**ADDENDUM NO:** One (1)

**PROJECT:** St John Elementary – Hurricane Laura Repairs  
CPSB Hurricane Laura Damages Restoration Program  
HL-050-01

**ARCHITECT'S PROJECT NO:** MA2124

**DATE:** April 27, 2023

**1** **POLE FOUNDATION DETAIL**  
NO SCALE

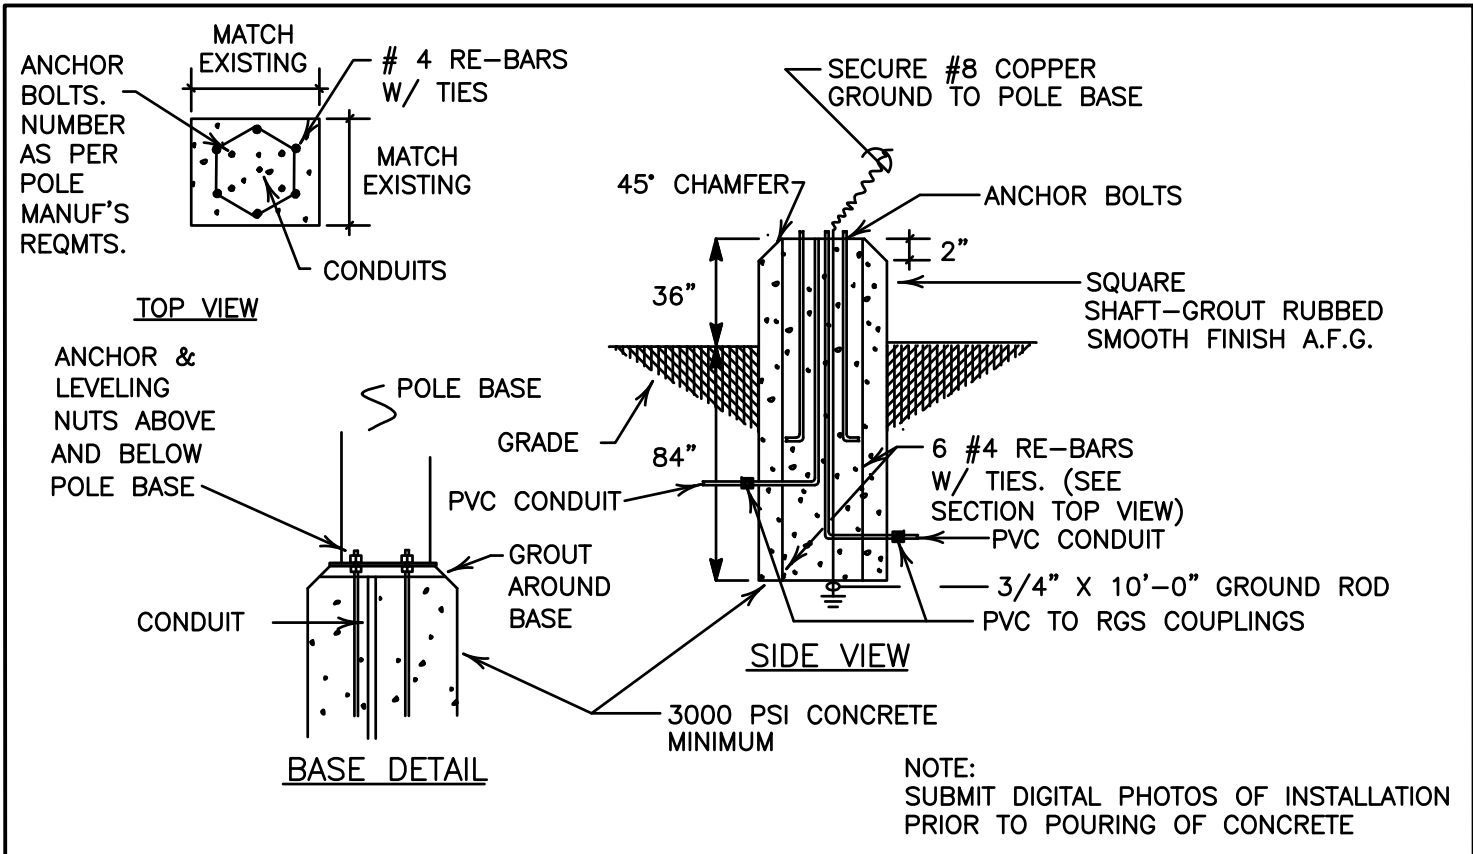
- 28) One existing parking area light pole is leaning. Electrical Contractor shall disconnect and remove this pole. Provide and install on 17" x 30" in-ground Quazite splice box on two (2) sides of concrete foundation – intercept existing conduit and feeds to allow for demolition and removal of concrete foundation. Provide and install new foundation per detail attached to this addendum. Extend new conduit and conductors into new foundation; re-install pole-plumb and level. (Conduits are 1" c; conductors are #8 cu).
- 29) Per General Note #1 Electrical Contractor shall refer to all Architectural drawings and perform all work required to allow for General Contractor repairs, i.e., new wall and ceiling surfaces. Remove and replace existing devices and fixtures to allow for said work. (Interior and Exterior)

- 30) Include attached, revised **Sheet E1.2** – Pole Foundation Detail in the Bid Documents.
